Project	IEEE 802.16 Broadband Wireless Access Working Group < http://ieee802.org/16 >	
Title	Procedure in community Entry of new BS	
Date Submitted	2006-04-30 	
Source(s)	Wu Xuyong, Jim Carlo Huawei Huawei Industrial Base, Bantian, Longgang, Shenzhen 518129 P.R.C	Voice: +86-755-28972324 Fax: +86-755-28975523 wuxuyong@huawei.com , j.carlo@ieee.com
Re:	80216h-06_011: Working Group Review: P802.16h Working Document (2006-04-07)	
Abstract	Procedure in community Entry of new BS	
Purpose	Comment on 15.2.1.3 Procedure in community Entry of new BS	
Notice	This document has been prepared to assist IEEE 802.16. It is offered as a basis for discussion and is not binding on the contributing individual(s) or organization(s). The material in this document is subject to change in form and content after further study. The contributor(s) reserve(s) the right to add, amend or withdraw material contained herein.	
Release	The contributor grants a free, irrevocable license to the IEEE to incorporate material contained in this contribution, and any modifications thereof, in the creation of an IEEE Standards publication; to copyright in the IEEE's name any IEEE Standards publication even though it may in

Figure h21—Initialization procedures — BS

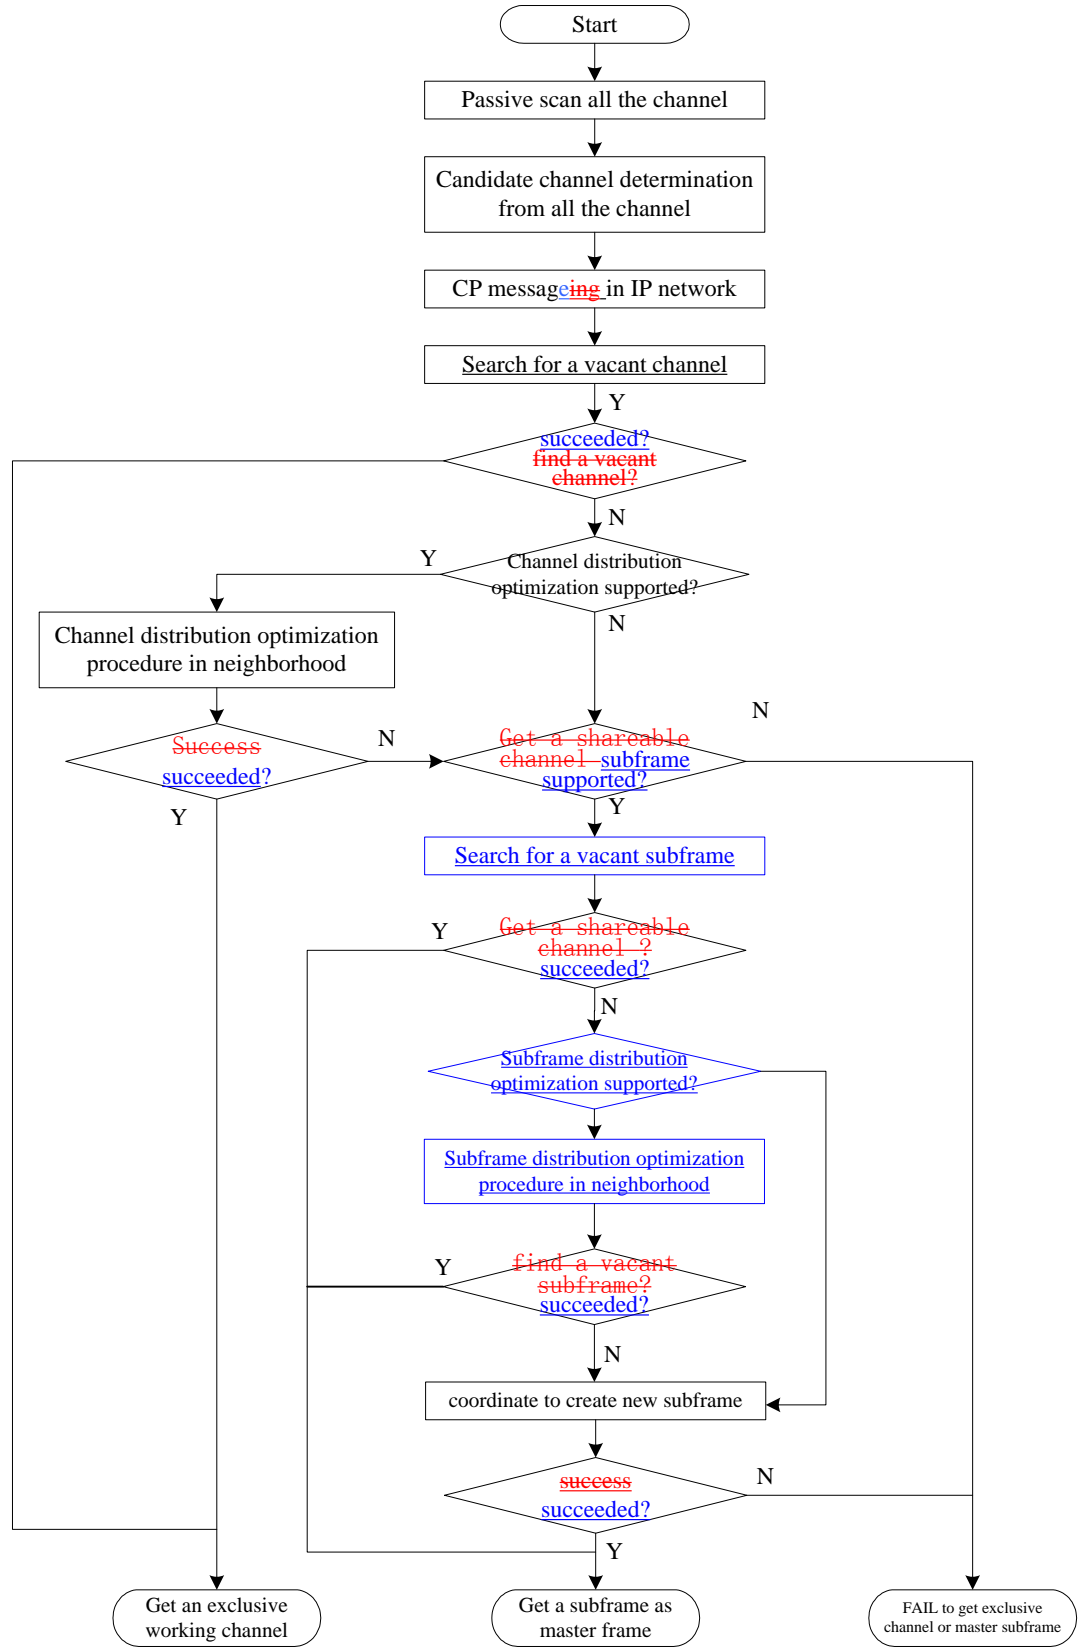
41 **Error! Reference source not found. Error! Reference source not found.** shows the initialization procedures for the
42 802.16 LE BSs. Note that the procedures that BS tries to create a Master slot or channel switching are also applicable for

1 operating stage. The detailed negotiation and update procedures are described in section **Error! Reference source not**
2 **found**, and **Error! Reference source not found**.

Figure h22—Initialization procedures - BS radio resource allocation

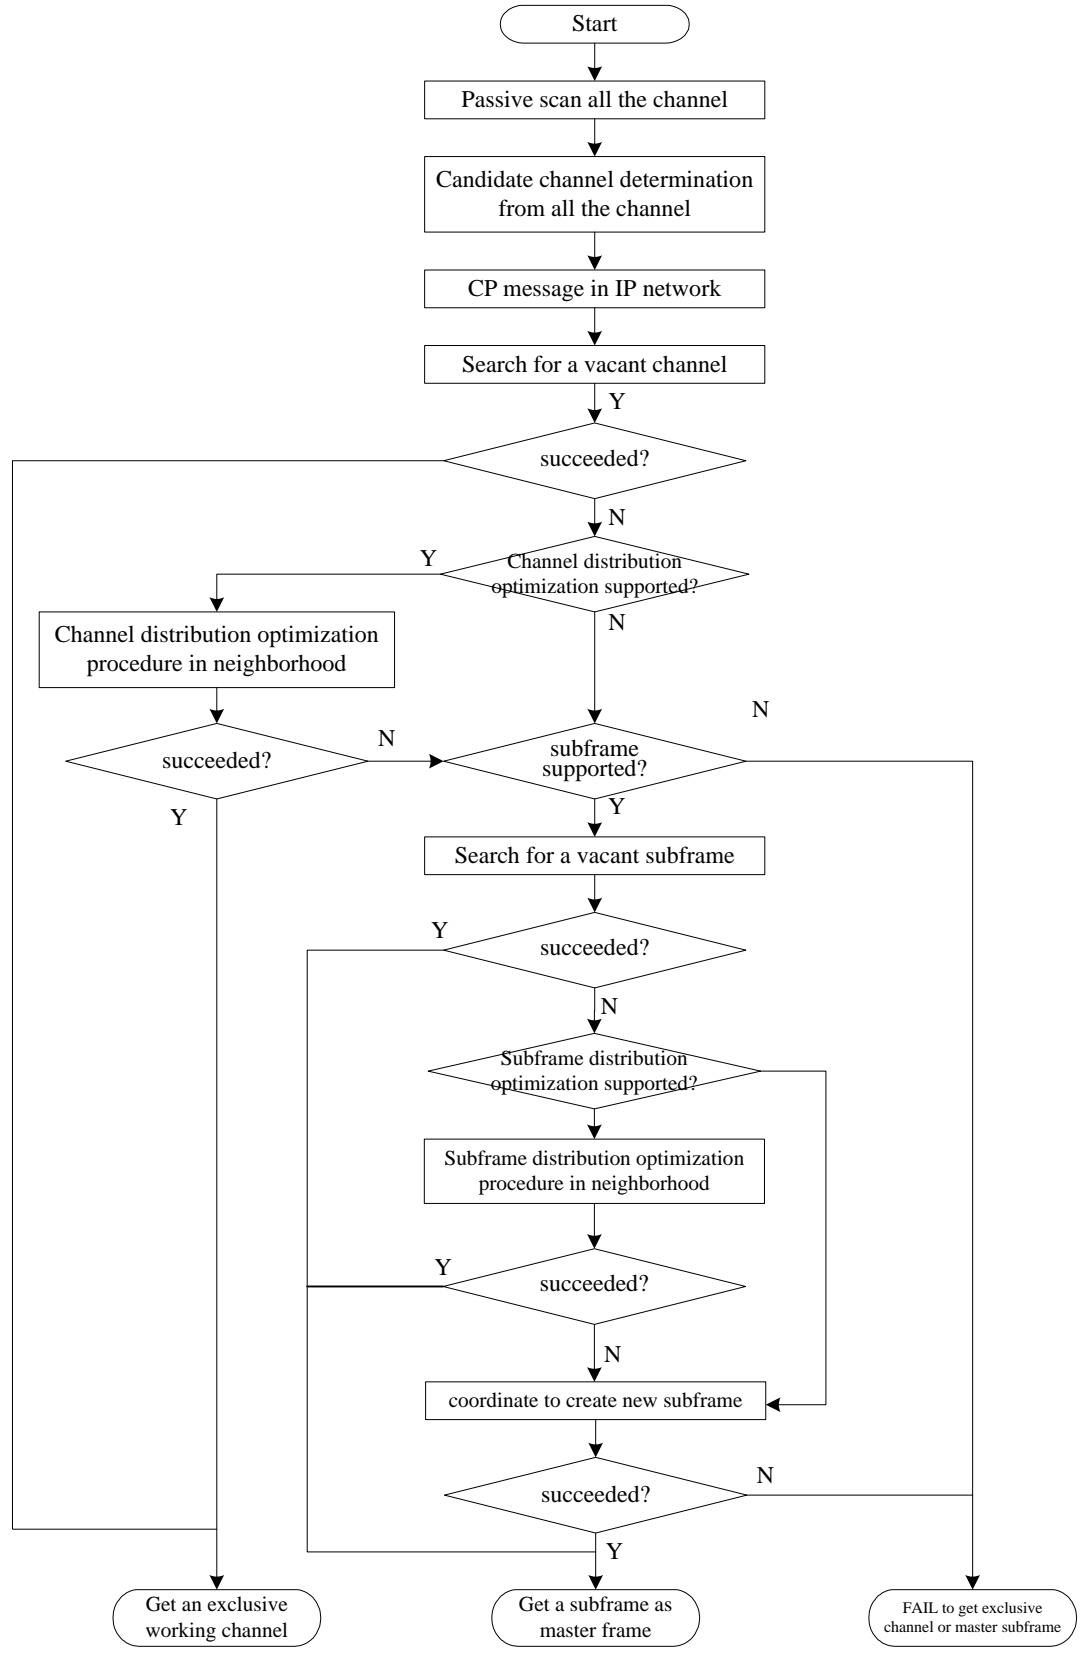
27 Similar to the channel allocation, the IBS will then first try to find a vacant sub-frame in the potential channels using the
28 information inside the distributed database, when failed IBS will then try to vacate an exclusive existing sub-channel by
29 sub-frame distribution optimization if supported. If a exclusive existing sub-channel is not available, IBS will then try to
30 negotiate with the systems inside the community to create a new sub frame. While all these attempt failed, the IBS will not
31 be able to get any interference free resource in its interference situation. These procedures are described in **Error!**
32 **Reference source not found. Figure h22.**
